Nant Mithil Energy Park, Powys.
PEDW DNS Application Ref: DNS CAS-01907-D7Q6Z1.

Nant Mithil Windfarm, Powys: Review of Application Documents Relating to Hydrology and Flood Risk.

February 2026
Technical Note Relating to Application Documents

Figure 1. The River Wye catchment at Erwood shaded in brown with the River Wye SAC in blue and the development site outlined in red (Background Map OS GB Cartographic Scale 1:300,000).

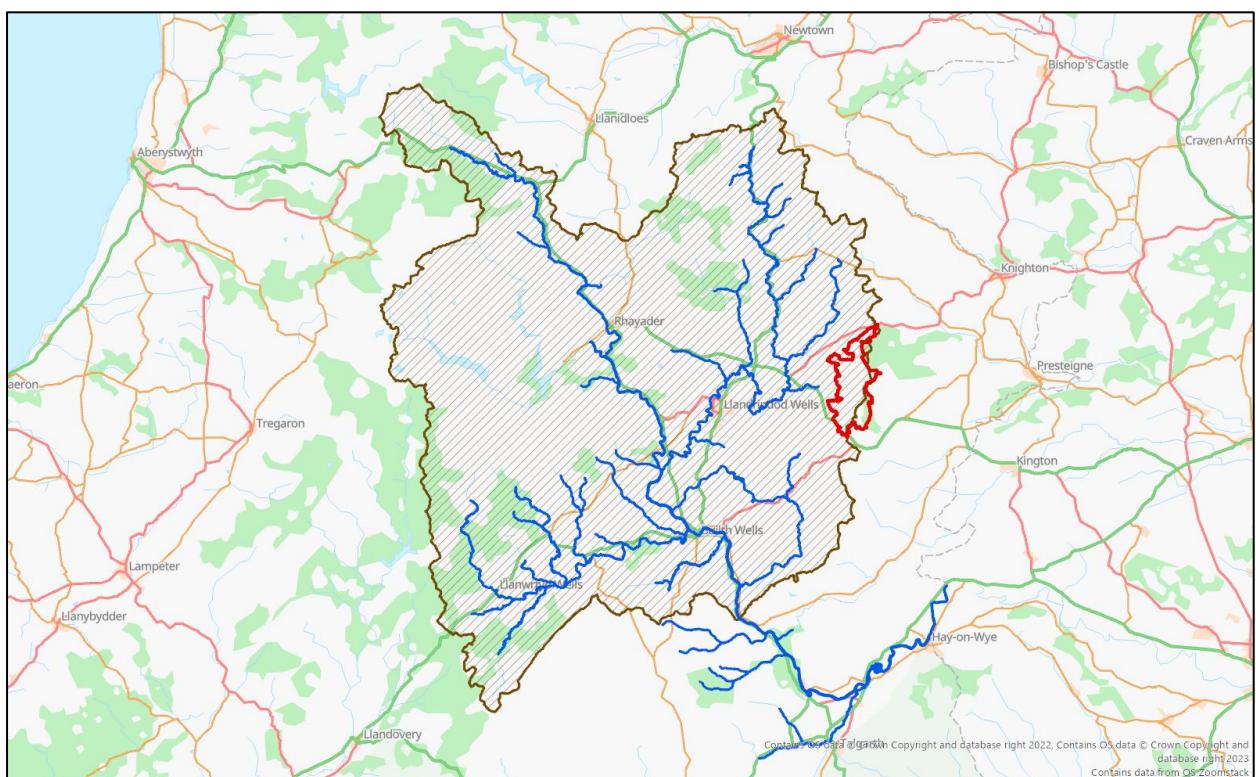
The document then provides some background to the study area although this is only a small section and it refers to the maps presented in the Figures listed above. There is no map showing the location of the site in relation the River Wye catchment and Special Area of Conservation (SAC) as shown in Figure 1 of this report. The section has series of scoping exercises looking at

The work undertaken here is generally thorough – however, the document would benefit from having maps showing the location of the proposed site in relation to the River Wye catchment, the SAC and SSSIs. This is shown in Figure 1 which highlights the extensive areas covered by the River Wye SAC.

Figure 2. 50 m watercourse buffers shown in green and 250m PWS buffers shown in blue in relation to the proposed development site (red outline) and turbine locations.

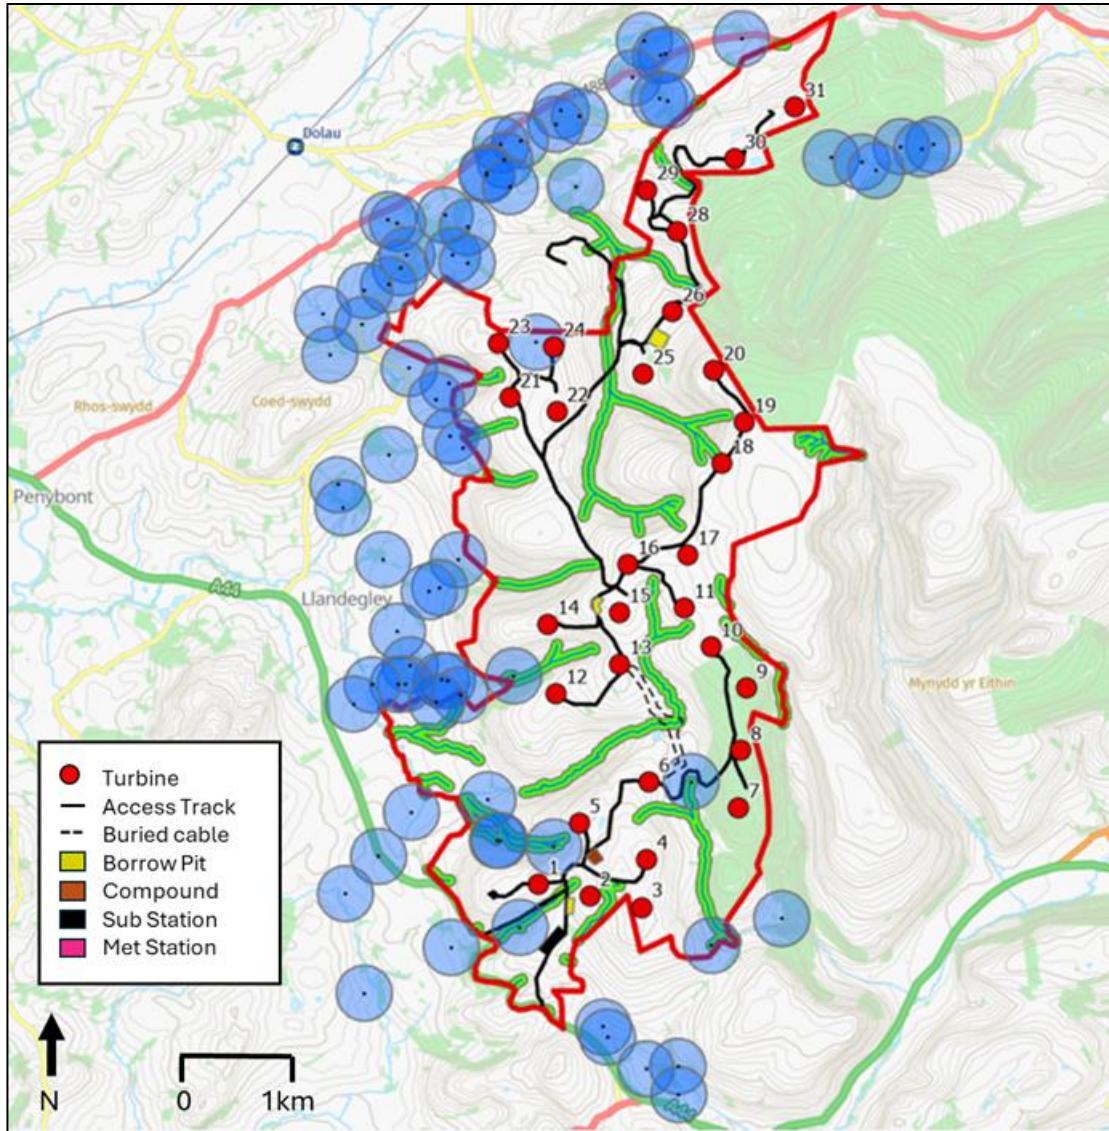
There is no map showing the extent of the buffers as stipulated from document 1. Using the information provided on the site layout, mapped locations of watercourses from OS data and information obtained giving the locations of water supplies from document 8, a new map was generated for this report which depicts the components of the development and the buffers in Figure 2. The location of turbine 24 is not meeting the imposed buffer distance as this falls within the 250m buffer for water sources. Likewise the sub-station extent, buried cable and access tracks near turbines 1 and 6 also encroach within a water source buffers. These water sources are identified as high risk in Figure 11.5. Document 2 also notes the presence of The Mithil Brook and Cwm Blithus Site of Special Scientific Interest (SSSI) within the development site. This designation is based on the geological character of the site, and the document has identified how the activities should be undertaken to maintain a good exposure of the features. The SSSI is shown

The greenfield runoff and storage volume requirements are missing however for the new access tracks. Given that these will extend over many km (see Figure 2) they will produce a considerable amount of surface runoff. Access tracks are present in the current land use of the development site, and these will often act as a conduit for overland flow during wet conditions due to the compacted surface from vehicle transport (Figure 4). Excavating infiltration trenches either side of any new tracks may not be possible given the steepness of the terrain and space restrictions with other types of land use. A typical track formation figure is shown in the appendix (Figure 4.10), but this has the infiltration trench on the upslope side of the track so the majority of the track surface runoff would flow away from the trench. Drawings of indicative water crossing designs are also provided in Figure 4.11.

The gradient of the tracks is also something which should be given more attention in relation to the hydrology as with a steeper gradient there will be a fast flow of water and infiltration would be minimal. Figure 2 also shows the contours at 10m intervals on the background OS map. The route taken by the tracks in some places is very steep. For example, between turbines 22 and 25 the route goes across the gradient up some 80m of altitude in just 450m, an average of 17% as shown in Figure 5. With a fast flow of water along access tracks used by heavy machinery there will also be a considerable potential for erosion. Document 4 has stated that check dams would be put in place along the infiltration trenches although their design would need to be informed by estimates of sediment erosion from hydrological modelling. A programme of maintenance is included within Table 4.8 of the document. Although not related to hydrology there is the question whether they would actually be feasible for the heavy machinery required for the turbine installation.

1. Maps should be provided by the applicant's consultants showing the defined buffer zones around all vulnerable features (water courses, GWDTEs and PWS) in relation to all aspects of the development (turbines, access roads, sub-station, cabling, storage areas and borrow pits). It appears from our assessment that some of the development lies within the proposed buffers;

Figure 4. Annual maximum flows on the River Wye at Erwood from the National River Flow Archive.

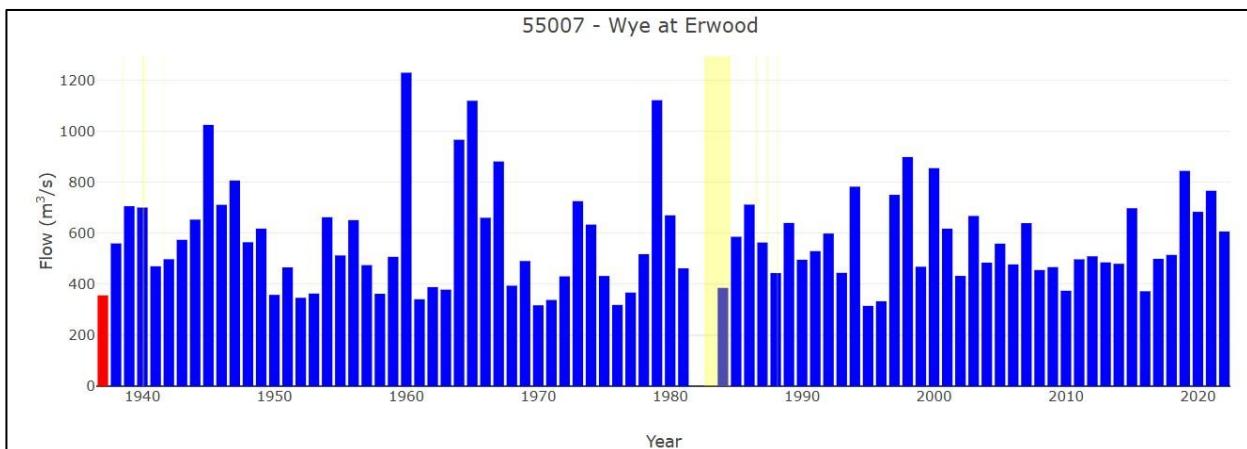
The information presented on historical flooding in Document 3 is lacking and is dismissed simply that according to NRW data the site has not experienced any historical flooding. This is a very misleading statement given that there are numerous watercourses across the site and as with any natural watercourse there would be times when the flows are severe and flood conditions are experienced. At the very least, the consultants could have shown the historical record from the River Wye, gauged at Erwood just 4km south of the development area, as shown in Figure 4. During times when the River Wye is in flood it is likely that the headwater streams within the development site would also have been affected. Other sources of information would be to consult the British Hydrological Society chronology of hydrological events database and the British Rainfall Digital Archive.
